TO: All Bidders
FROM: City of Cambridge
DATE: January 22, 2013
RE: File No. 5994 – Danehy Park Artificial Turf Field Project - Addendum No. 4

Artificial Turf Field Project, Soccer Fields 1 and 2, Danehy Park, Cambridge, MA

ADDENDUM NO. 4

CHAIN LINK FENCE TYPE 2

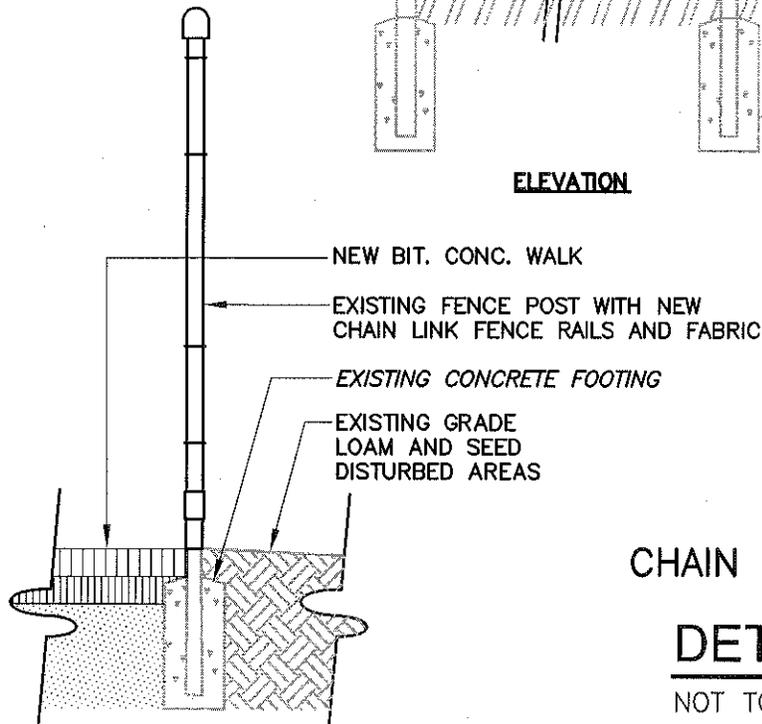
On sheet L-5, **REPLACE** Detail 3 with the attached revised detail.

FOR ALL TYPE 2 FENCE, REMOVE EXISTING CHAIN LINK FENCE FABRIC AND RAILS AS NOTED. STRAIGHTEN POSTS AS REQUIRED. INSTALL NEW 4-FT HIGH CHAIN LINK FENCE TO LIMITS SHOWN.

ADD ALT: CHAIN LINK FENCE TYPE 3

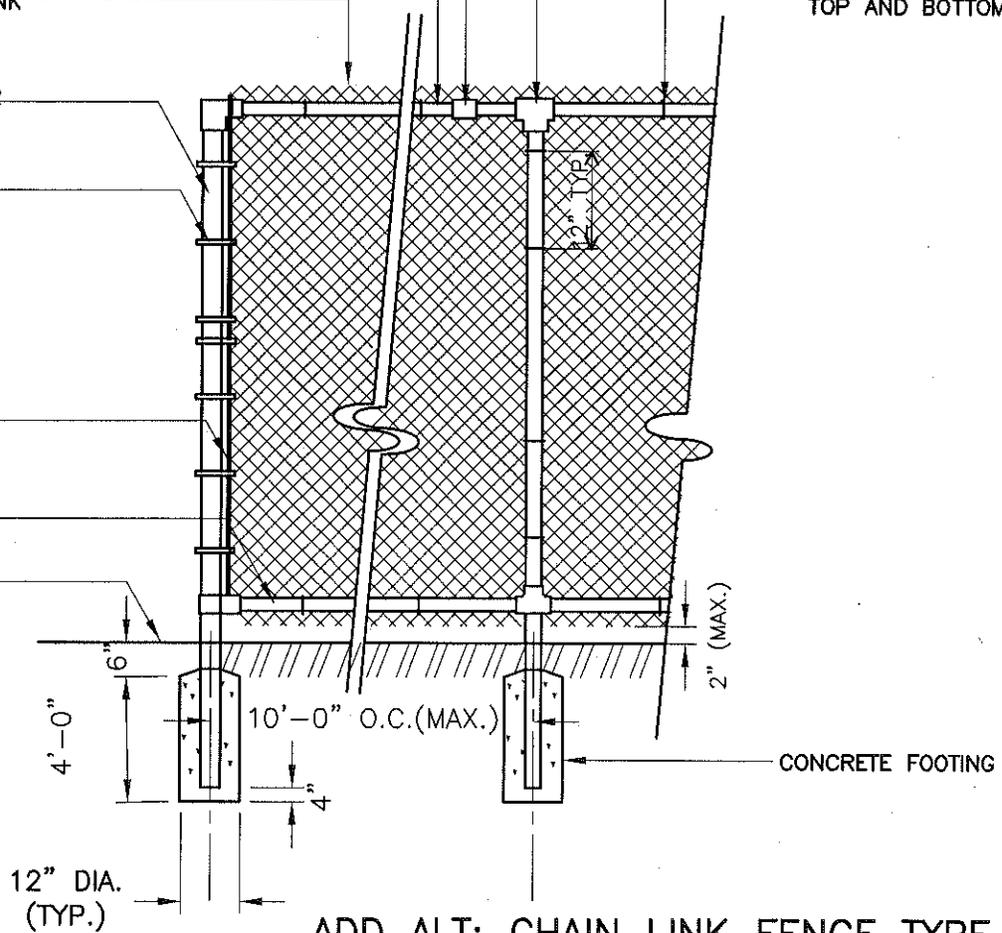
| Question #1: | It is clearly specified and described in detail to provide a 2.5" round fence post to sleeve over the existing square ornamental fence posts in the process of constructing a new 4' clf fence system along New Street. The problem lies in that the existing fence posts are 2.5" x 2.5" square posts and the smallest round pipe that can fit of the square is 4" fence pipe. Please advise if we are to carry 2.5" round pipe for sleeving or 4" round pipe for sleeving? |

On sheet L-5, **REPLACE** Detail 4 with the attached revised detail.

| Response | Refer to reissued Detail 4 as attached. |

1. REMOVE EXISTING ORNAMENTAL FENCE IN ITS ENTIRETY AND REPLACE WITH NEW 4-FT HIGH CHAIN LINK FENCE.
2. FENCE FOOTINGS SHALL BE AUGURED HOLES. CONTRACTOR SHALL REMOVE AND DISPOSE OF EXISTING TOPSOIL AND GRAVEL. REMOVE MBTA SUBGRADE FILL FOR REUSE ON SITE.
3. SUBGRADE SOILS CONSIST OF TOPSOIL, GRAVEL SOIL (MIN. 6") AND MBTA FILL (APPROX. 15FT.) SEE GEOTECHNICAL INFORMATION APPENDED TO SPECIFICATIONS FOR SOIL MATERIALS AND DEPTHS ANTICIPATED TO BE ENCOUNTERED WITH EXCAVATIONS.
4. REMOVE EXISTING POSTS AND FOOTINGS. NEW FOOTINGS SHALL BE LOCATED IN THE SAME LOCATIONS. ANY EXCAVANT REMOVED SHALL BE PLACED ON SITE IN AREAS AS INDICATED ON THE PLANS.
